Interactive comment on “Behavior analysis by model slope experiment of artificial rainfall” by M. C. Park

Anonymous Referee #1

Fig. 1.

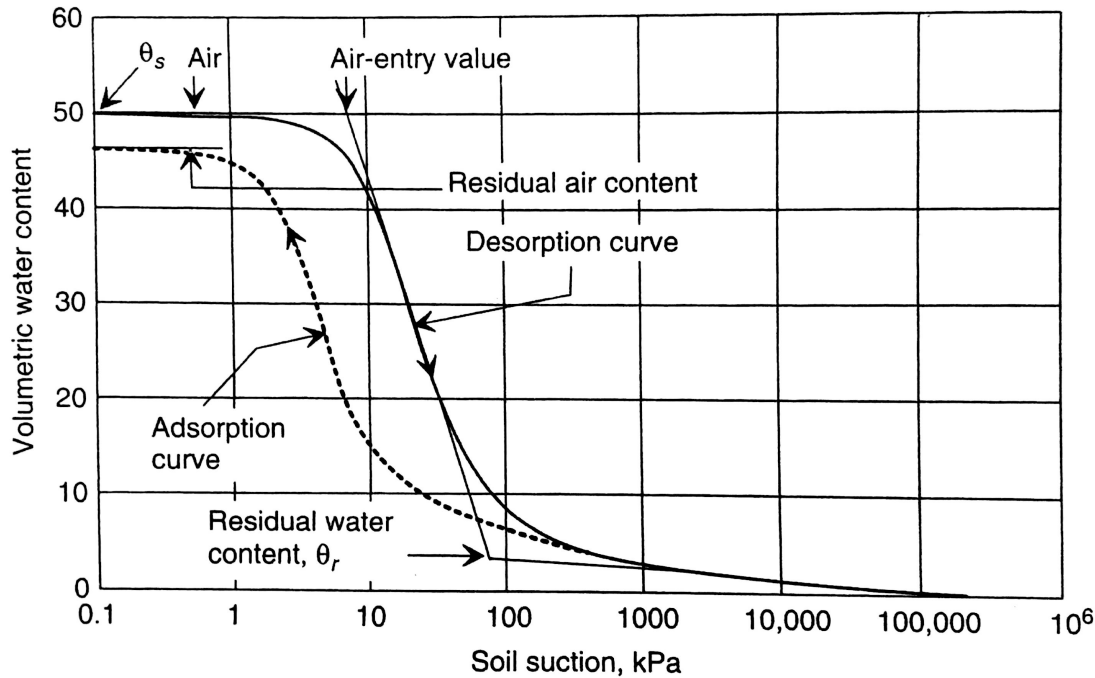
Question : The last point regards the interpretation of the soil parameters. The authors assign an air-entry value of 0.452, which is quite suspect. As far as I know, the air-entry value should be the point where air enters in the pore, i.e., the point where the curve deviates from the saturation. In the fitting of the data, this point is very close to the origin, which means that the material practically does not have any capillarity fringe (that is normal, indeed). Therefore, the air entry value should be low, almost 0, in my opinion.

- Answer : For seepage analysis, these are required the residual water content θ_r , the air entry pressure u_b , and the pore size distribution parameter n . The SWRCs were obtained from the pressure plate tests and fit to the van Genuchten model using the RETC code (Van Genuchten, 1980). Also, the air-entry value is also very similar compared to the figure below from the reference. It is a different value depending on the state of the soil, an air-entry value of 0.452 will not be a problem.
